## SPRINGDALE SOLAR FARM

Independent Planning Commission

Request for Information (RFI) Report

Author	Steven Reid
Date	05 February 2021
Ref	04317-2039267

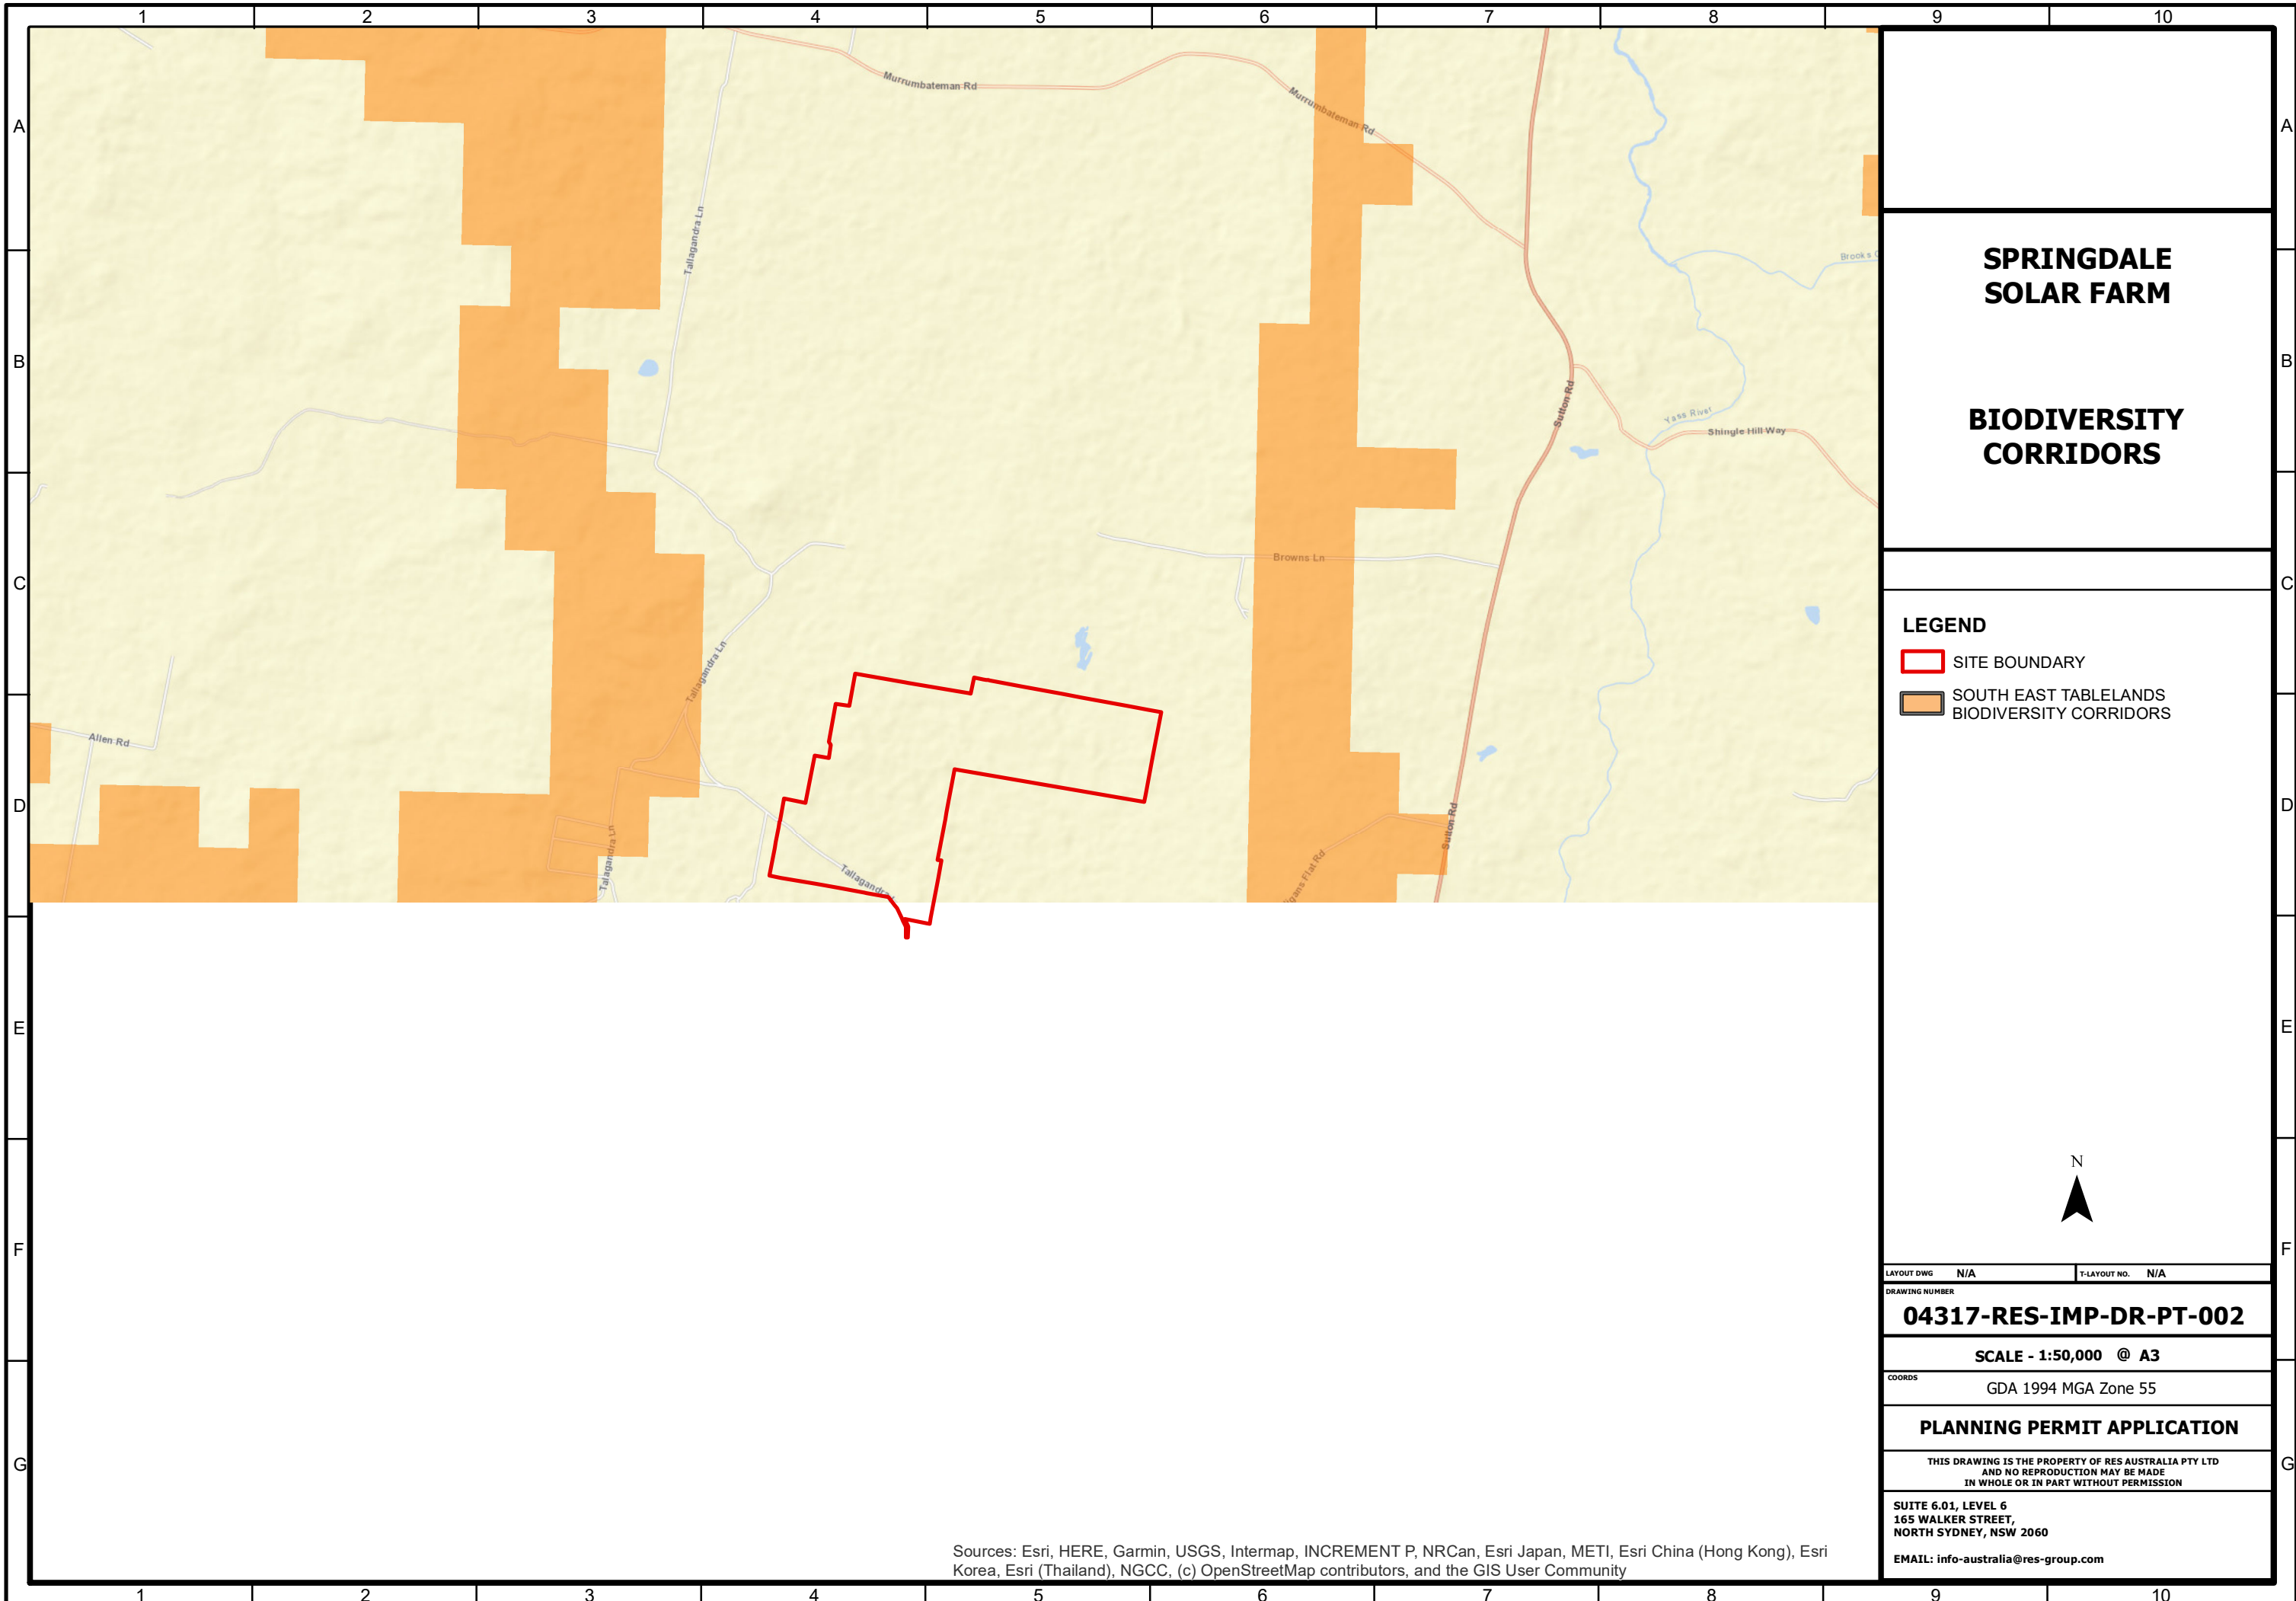
IPC - RFI	Proponent Response
<ul style="list-style-type: none"> <li>– <u>Biodiversity corridor</u>: please provide maps.</li> </ul>	<p>See plan attached at Annexure 3.1</p>
<ul style="list-style-type: none"> <li>– <u>Conservation area</u>: what works are proposed to enhance the area? How will grazing regimes be managed?</li> </ul>	<p>The conservation area referred to is assumed to be the Golden Sun Moth (GSM) conservation area located to the western side of the main solar array. This area comprises 60 ha set aside and managed for the benefit of GSM.</p> <p>As outlined in the EIS, the project was substantially redesigned to avoid key areas of GSM habitat within the Project site following expert ecological survey. This avoidance is the key element of the Proponent's response to conserving this species within the Site for the duration of the solar farm's operation.</p> <p>In addition to this, measures proposed with view to enhancing the habitat and success of this species within the Site include:</p> <ul style="list-style-type: none"> <li>• Management of grazing regimes during operation to maintain optimal grass species, height and coverage. This will include specific management of the type of livestock (likely sheep) and the density of stocking to maintain key habitat values relevant to the species' long term success. Specifically, the Proponent will seek to maintain tussock levels between 3 and 15 cm by regulated grazing, with shorter heights achieved by October before the GSM flying period, and lighter grazing from November to January if the season is dry.</li> </ul>

<ul style="list-style-type: none"> <li>• Where grazing is not deemed practical or is constrained by other factors optimal grass heights would be maintained by slashing</li> <li>• Pasture improvement practices that may result in detrimental effects upon GSM, such as the use of fertiliser and sowing of exotic pasture grasses, would be discontinued within the GSM conservation zone</li> <li>• Existing grassland areas throughout the Site subject to disturbance during construction would be rehabilitated using locally sourced Wallaby and Speargrasses</li> <li>• Weed management would be maintained within the GSM conservation zone to control broad-leaved weeds that may shade out grasses providing GSM habitat</li> <li>• Provision of high quality and suitable fencing around both the site and the GSM conservation zone to prevent stray livestock entering (from both other parts within the Site and adjacent landholdings) and potentially damaging the conservation area through direct trampling and/or localised overgrazing</li> </ul> <p>The above measures would be included within a GSM-specific sub-plan of the Biodiversity Management Plan, as required by the draft conditions of consent. This plan would be developed in consultation with Alison Rowell, the leading local expert on the ecology and conservation of this species.</p> <p>Implementation of the GSM sub-plan would be undertaken by the Proponent, with the assistance of the existing landowner, whom the Proponent will permit to maintain grazing activities over the Site in accordance with the GSM sub-plan.</p>

<p>Updates to the Main Constraints map:</p>	
<ul style="list-style-type: none"> <li>– <u>Water usage</u>: please provide information on water usage during construction and operation.</li> <li>–</li> </ul>	<p>Water consumption rates for solar farms vary substantially depending on local climatic conditions and the specific technology implemented. It is noted that the EIS states that 2 ML and 1.6 ML of water would be required annually during construction and operations, respectively.</p>
